**ICC 500-2020 edition  
Public Input Agenda with  
Committee Votes and Public Comments  
based on input received  
on 2014 edition of the  
ICC 500 Standard**

**For February, 2020  
2<sup>nd</sup> Meeting – Teleconference**

## 2014 ICC 500-Standard Revision Proposals – Public Comments

Figure 504.1.2

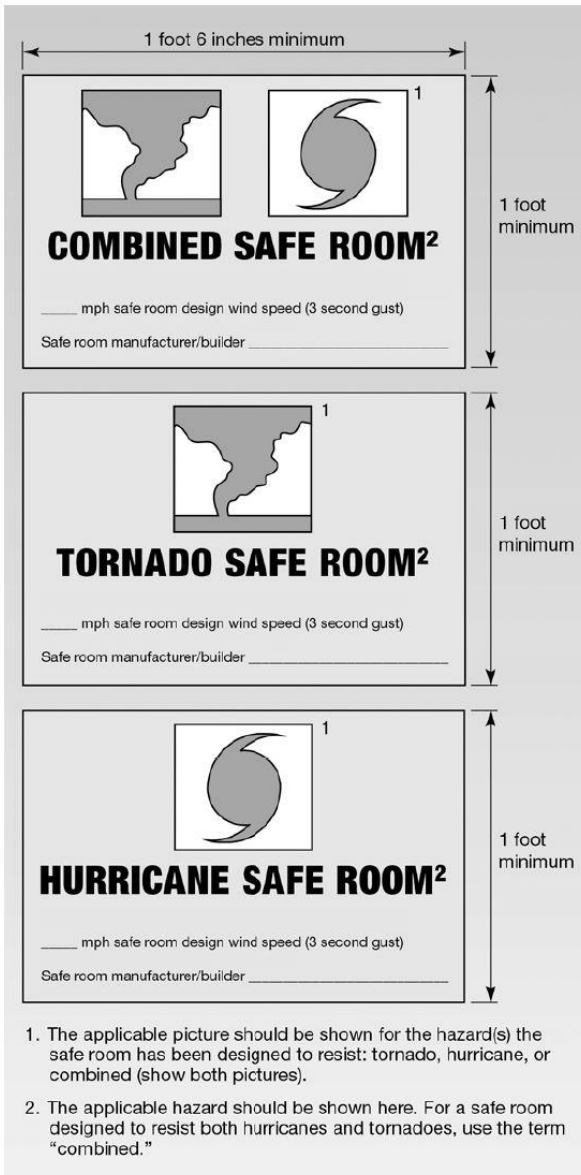
**Staff Note:** Modifications were also submitted for Commentary Figure 504.1.1 and 504.1.2

Add “Tornado Shelter Design Capacity: 1,500” to Figure 504.1.1.

Add “Tornado Shelter Design Capacity: 2,500” and “Hurricane Shelter Design Capacity: 1,500: to the top sign in Figure 504.1.2.

Add “Tornado Shelter Design Capacity: 400” to the middle sign in Figure 504.1.2.

Add “Hurricane Shelter Design Capacity: 2,000” to the bottom sign in Figure 504.1.2.

**Committee Action: As modified (7-0 meeting) (12-0 electronic vote)**

**FIGURE 303.2 303.1.1**

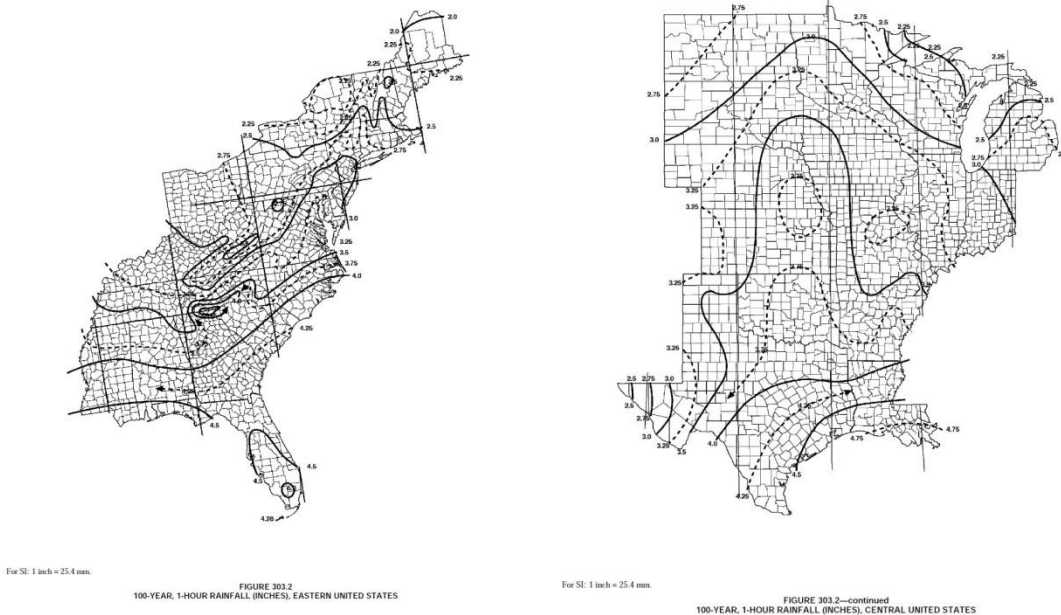
**Reason:** Figure 303.2 is referenced in Section 303.1.1 and not in Section 303.2. Section 303.2 has nothing to do with the figure.

*(Add figure for Western United States, Hawaii, Alaska and the American territories listed in ICC 500 Figure 304.2.1) 10-19-2018: See IS-STM-07-15-18 for Hawaii Map*

**303.1.1. Rainfall rate.** The rainfall rate shall be determined by adding 6 inches (152.4 mm) of rainfall per hour to the 100-year, 1-hour rainfall rate established from Figure ~~303.2~~ 303.1.1. For locations not illustrated in the figure, determine the 100 year, 1-hour rainfall rate from approved local weather data.

Figure 304.2(2) SHELTER DESIGN WIND SPEEDS FOR HURRICANES

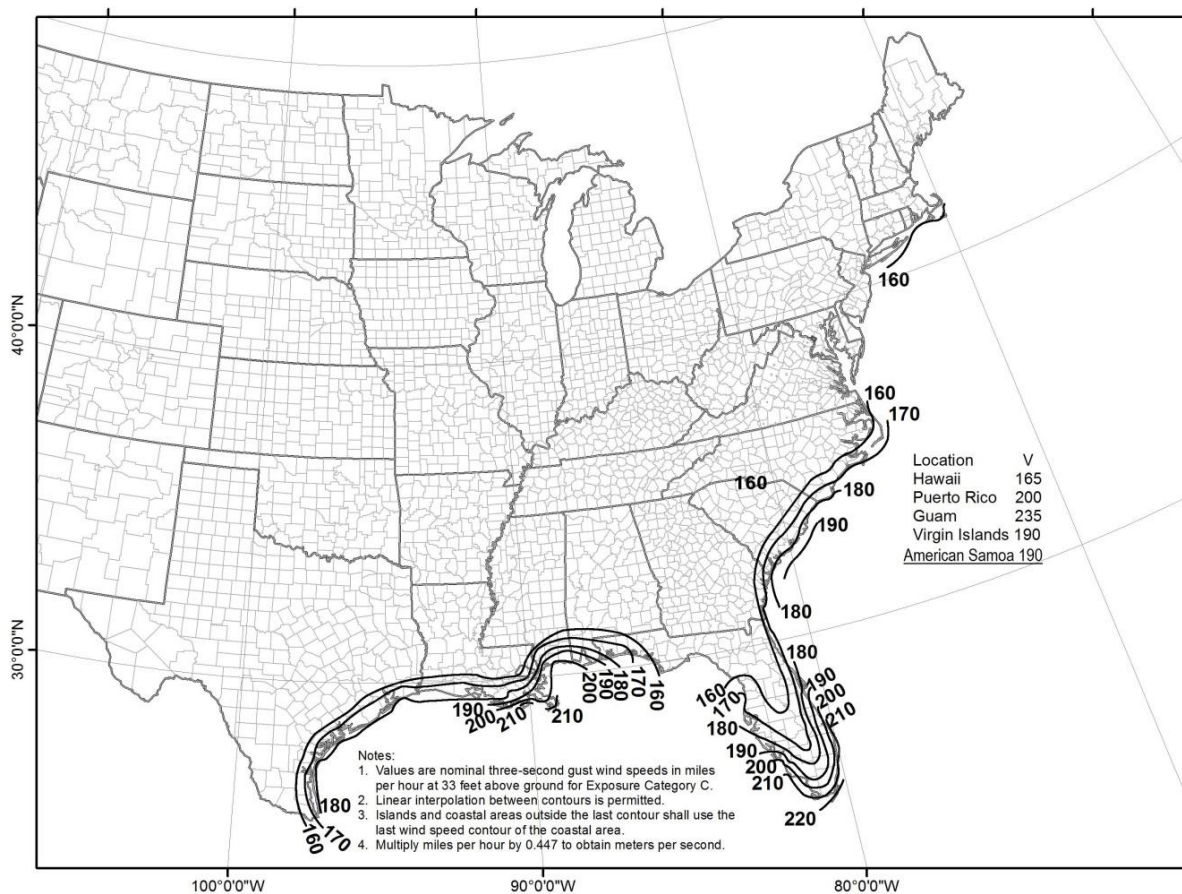
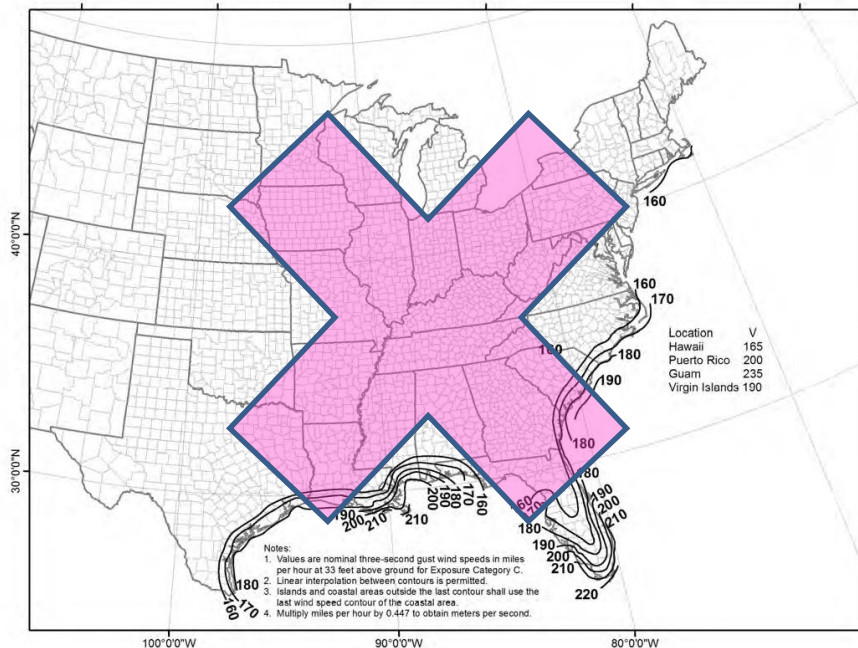
**Reason:** Currently Figure 304.2(2), the Shelter Design Wind Speeds for Hurricanes, does not specify a design wind speed for American Samoa where hurricanes are the greatest high wind hazard, and a 10,000 year MRI analysis is not currently available. From the ASCE 7 wind speed maps for 300, 700, 1700, and 3000 years, it turns out that the Virgin Islands and American Samoa wind speeds at each of these return periods are almost identical, meaning the hazard curves have a similar shape at the two locations. On the ASCE 7-16 Risk Category IV map,

American Samoa and the US Virgin Islands both have design wind speed of 180 mph. Therefore, the proposed wind speed for American Samoa is the same as the 10,000 year MRI wind speed that is currently used for the US Virgin Islands, 190 mph.

*Notes: Will also revise name for US Virgin Islands and add Commonwealth of the Northern Mariana Islands and American Samoa to full map. ARA will provide revised map for standard.*

*Rotate maps to landscape in final draft.*

### Committee Action: Approved as Modified (10-0)

**FIGURE 304.2(2)**  
**STORM SHELTER DESIGN WIND SPEEDS,  $V$ , FOR HURRICANES**

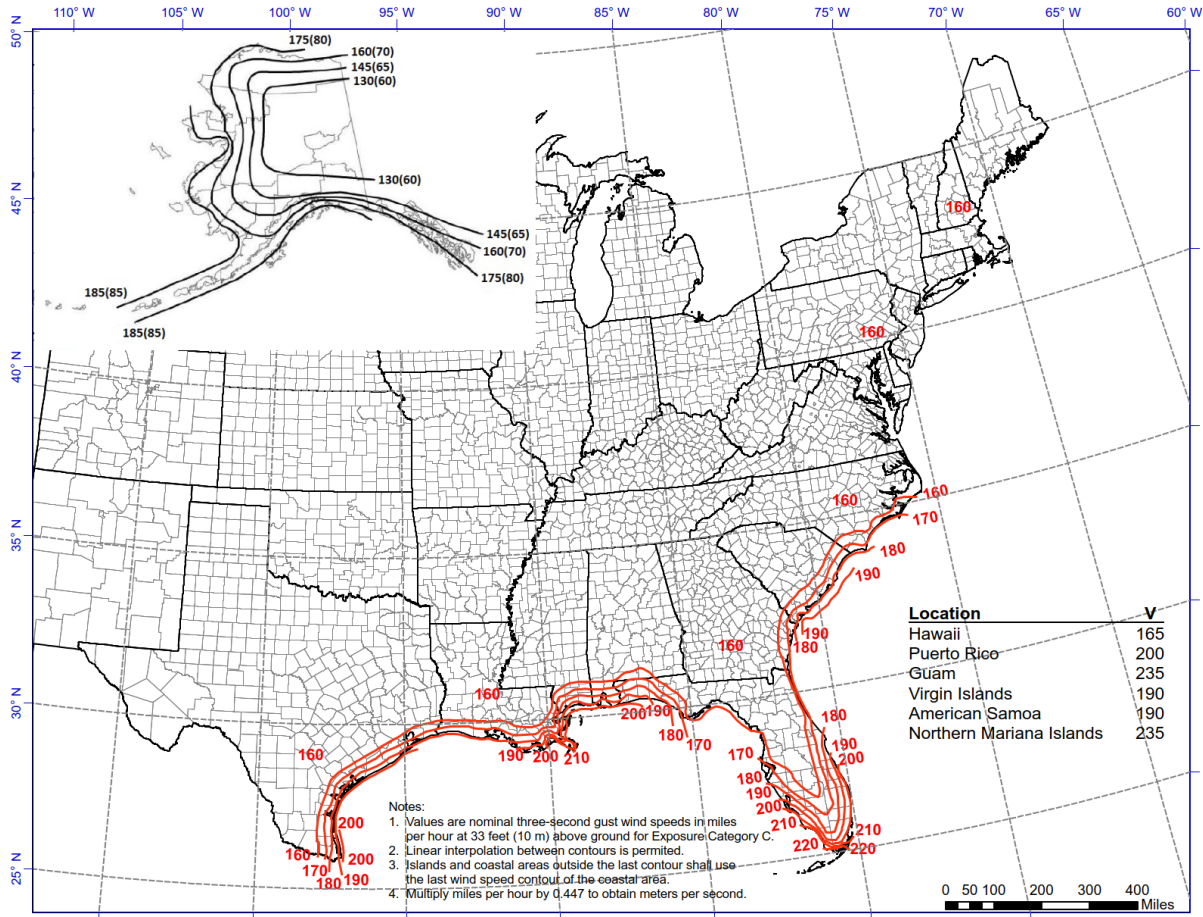
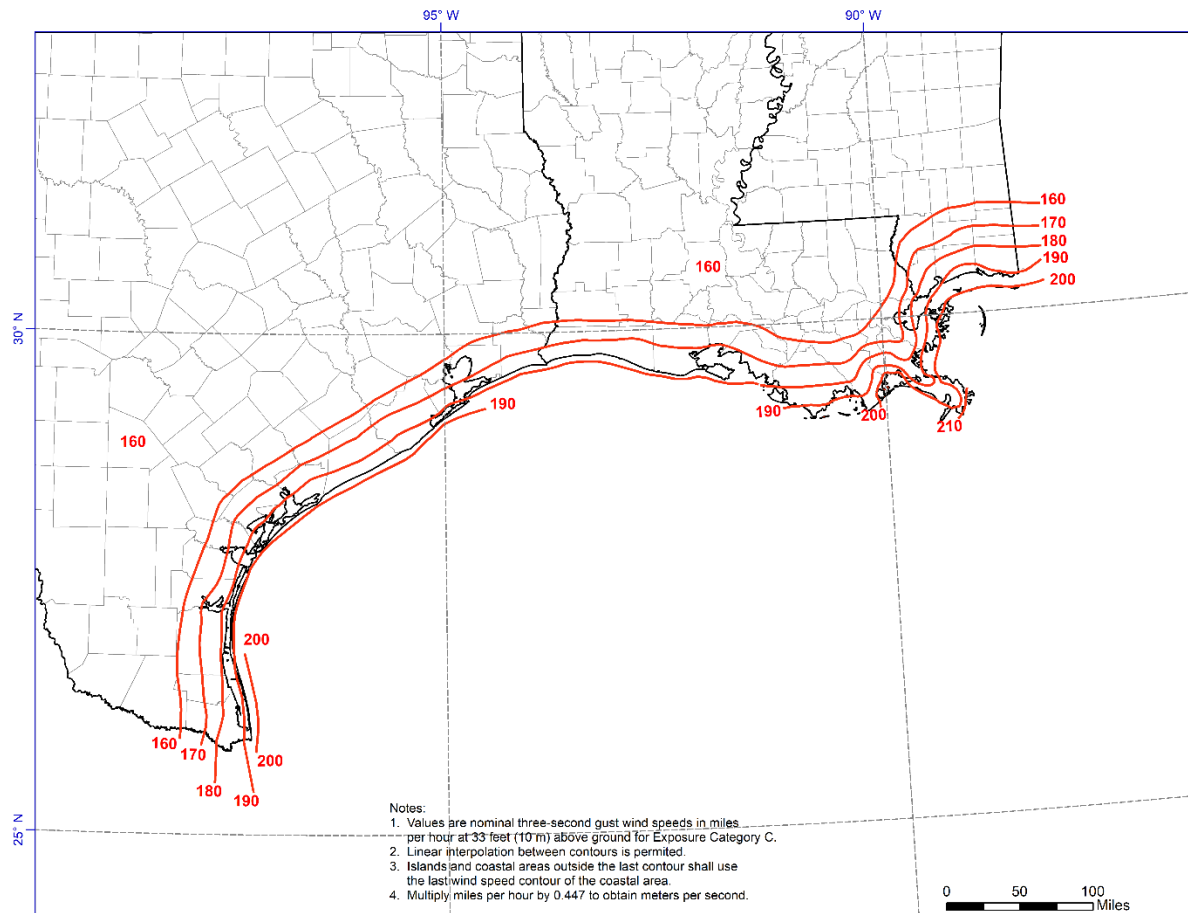
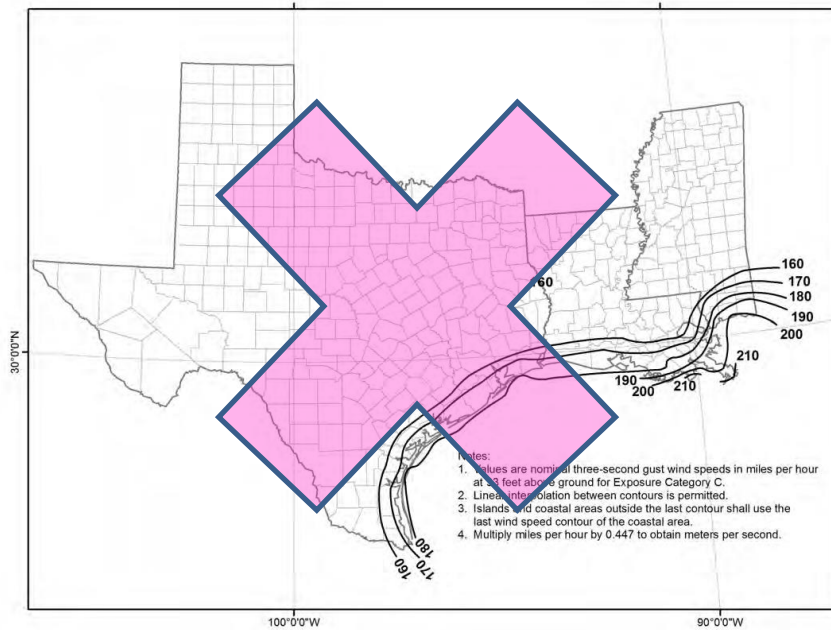
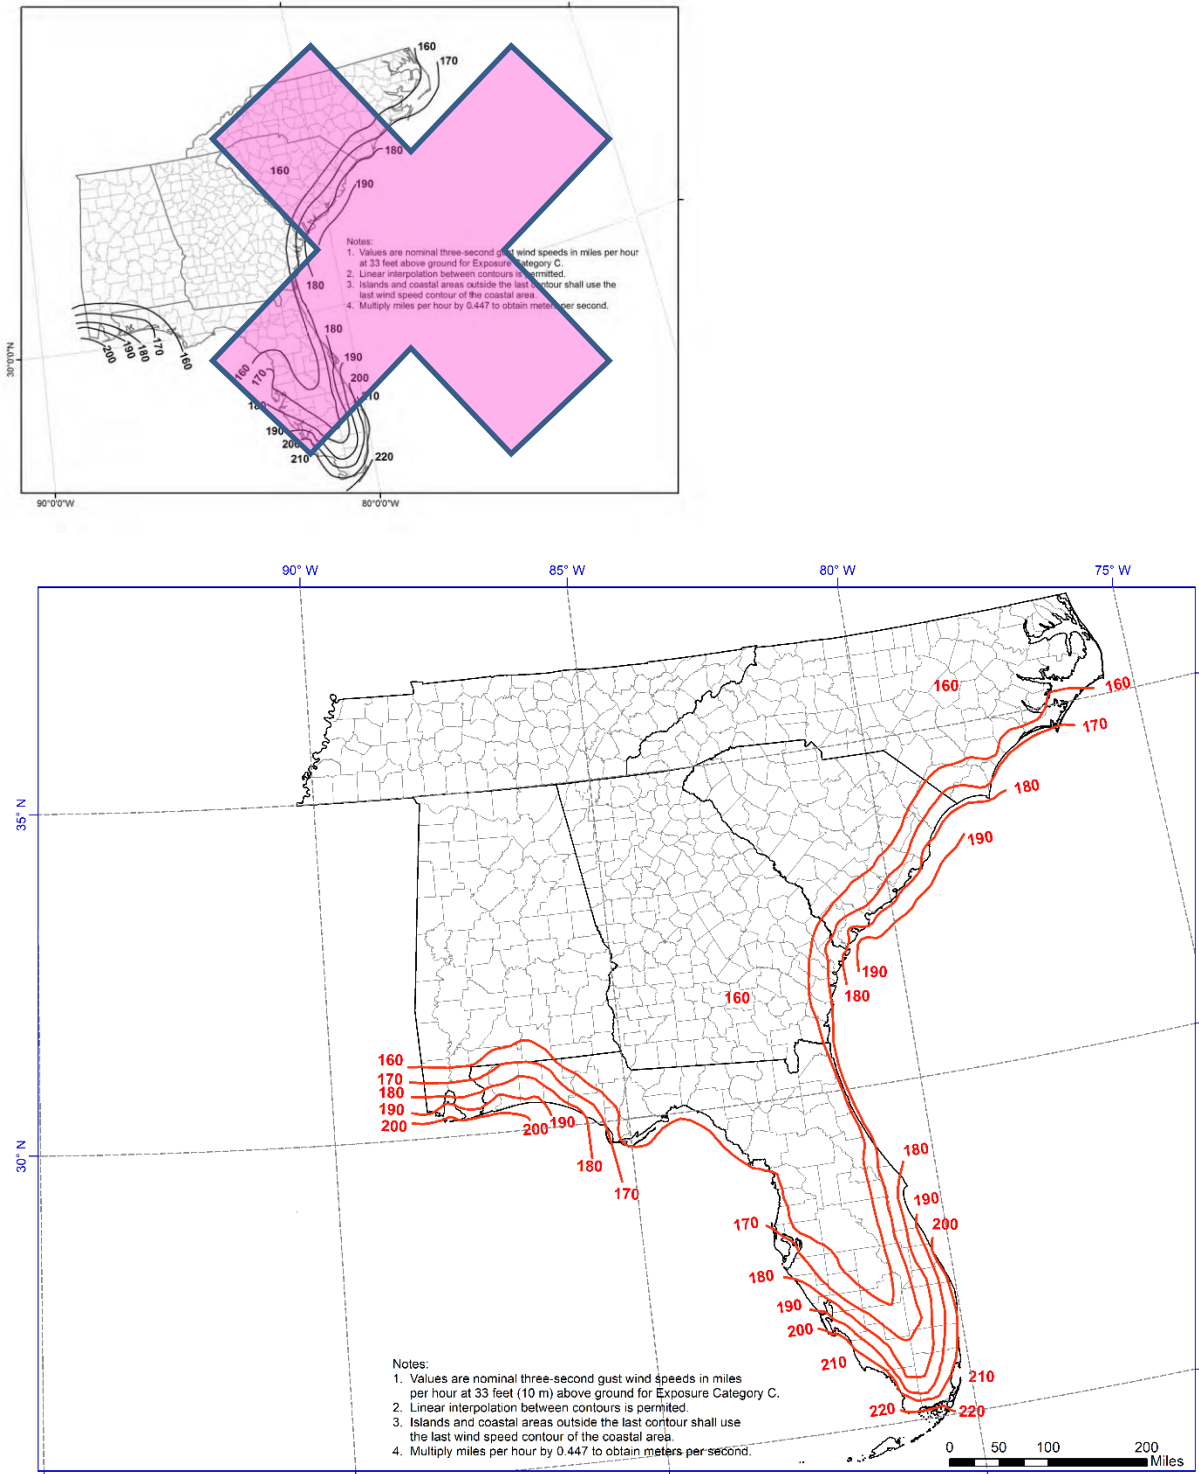
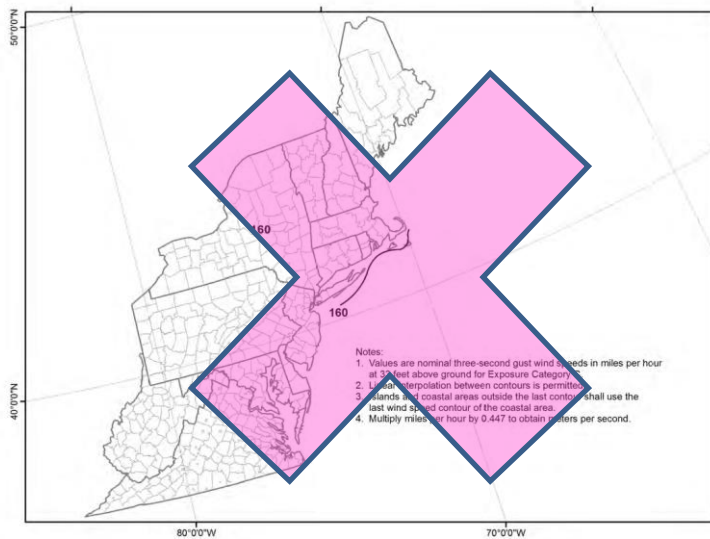
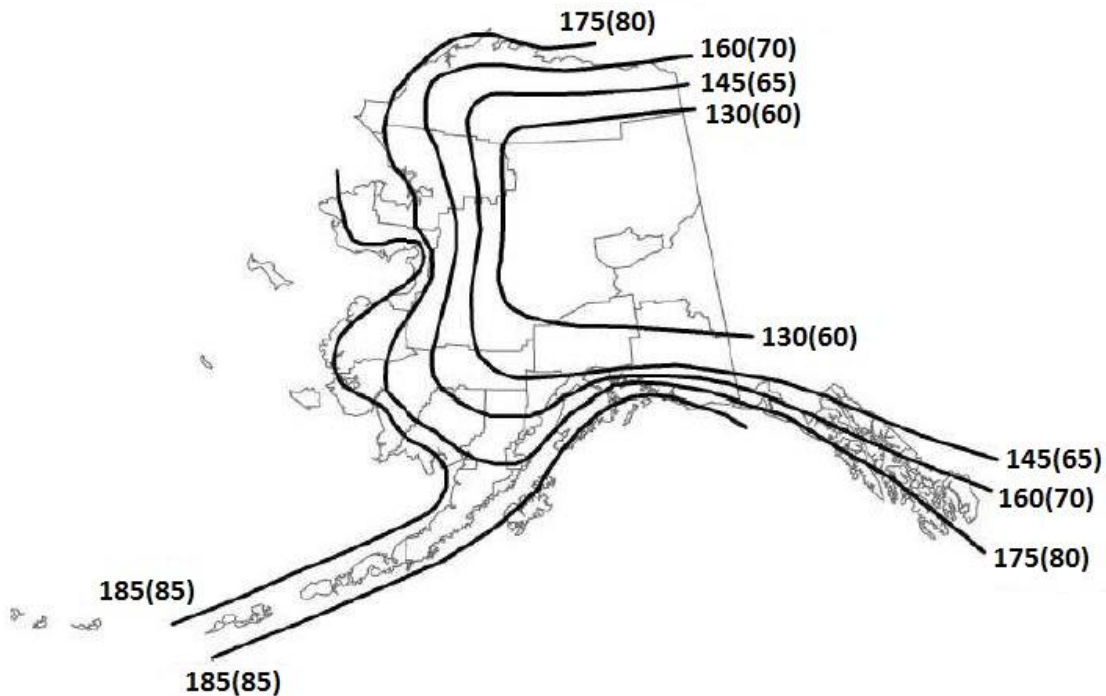
Delete four current maps and replace with the following

**Committee Reason:** Revised maps to coordinate with latest information for hurricane winds. Add Alaska because that state is affected by hurricane winds. Full list of islands is needed.

**FIGURE 804.9.5(3)**  
**ROLLING DOOR ASSEMBLIES**

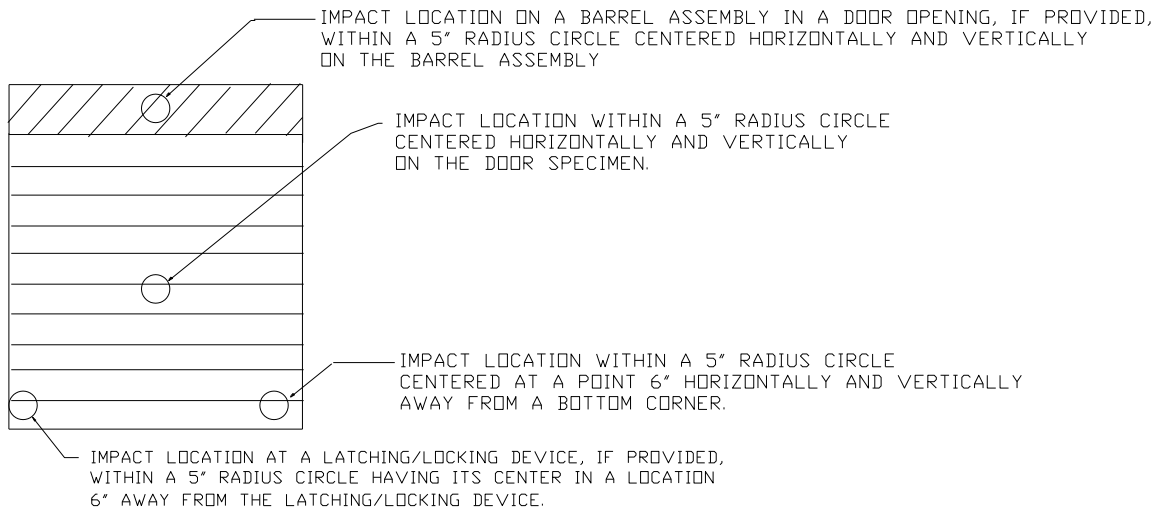
For rolling door assemblies, the door shall receive two impacts as shown in Figure 804.9.5(3) plus an additional impact on a latching/locking device if provided, plus an additional impact on a barrel assembly if mounted in the door opening.

**Reason:** Clarify application of door impact provisions with respect to testing of rolling and sectional doors

**FIGURE 804.9.5(4)**  
**SECTIONAL DOOR ASSEMBLIES**

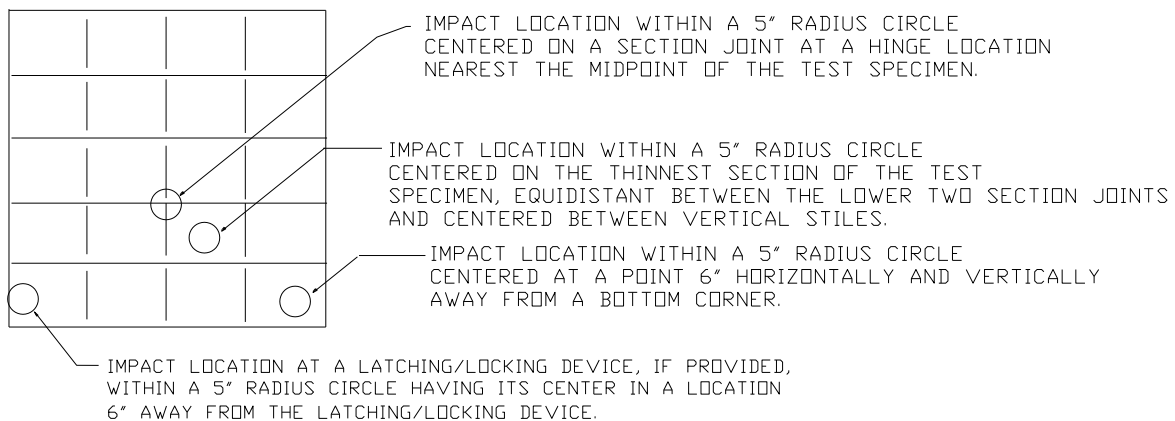
For sectional door assemblies, the door shall receive three impacts as shown in Figure 804.9.5(4) plus an additional impact on a latching/locking device if provided.

**FIGURE 804.9.5.2**  
**ROLLING DOOR ASSEMBLIES**

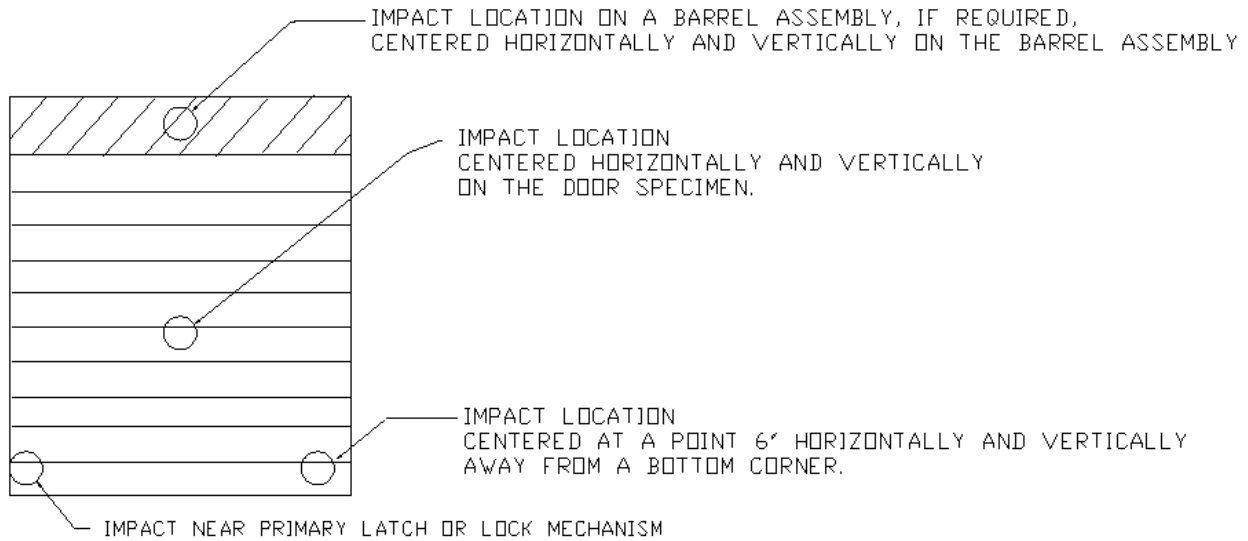
**804.9.5.2 Rolling door assemblies.** For rolling door assemblies, the door shall be impacted at the center of the door, at one bottom corner and within 6 inches (152.4 mm) of primary latches or operators, plus an additional impact centered on a barrel assembly as shown in Figure 804.9.5.2.

**Exception:** The barrel assembly is not subject to the additional impact where the entire barrel assembly is protected by the shelter envelope.
